Authorized Field Change

AFC 13908

Subject File: Clutch

Subject: 9900® and Paystar® Clutch Adjustment for Certain Vehicles Marked in Service PortalSM with AFC 13908

Figure 1. Clutch Relay Lever (Bell Crank Lever).

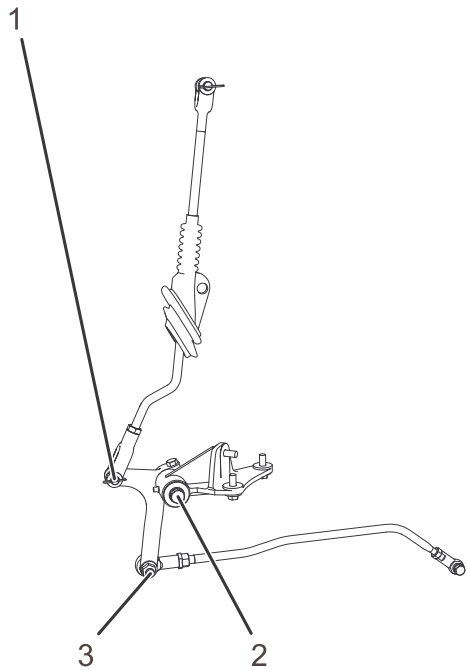
Certain 9900® and PayStar® models may not be able to obtain the proper clutch adjustment specification. If the clutch is not adjusted properly, this can cause improper clutch pedal free play, or the clutch brake may not function properly. If the clutch cannot be adjusted correctly, this AFC provides the service procedures to replace the vertical clutch rod and bell crank (clutch relay lever).

1. Clutch rod vertical linkage
 2. Clutch relay lever connection to bracket
 3. Clutch relay lever horizontal linkage
4. Disconnect clutch rod vertical linkage (Figure 1, Item 1) from clutch relay lever (bell crank).
 5. Disconnect horizontal linkage (Figure 1, Item 3) from clutch relay lever.
 6. Remove clutch relay lever (Figure 1, Item 2) from clutch relay lever bracket.

1. Install new clutch relay lever (Figure 1, Item 2) on clutch relay lever bracket.
2. Install horizontal linkage (Figure 1, Item 3) to clutch relay lever.
3. Install new vertical clutch rod linkage (Figure 1, Item 1) to clutch relay lever.

NOTE: Make sure all spring clips are properly installed in the clevis pins.

4. Verify clutch adjustment. Refer to appropriate Service Manual for clutch adjustment.
5. Close and latch hood.
6. Remove wheel chocks.
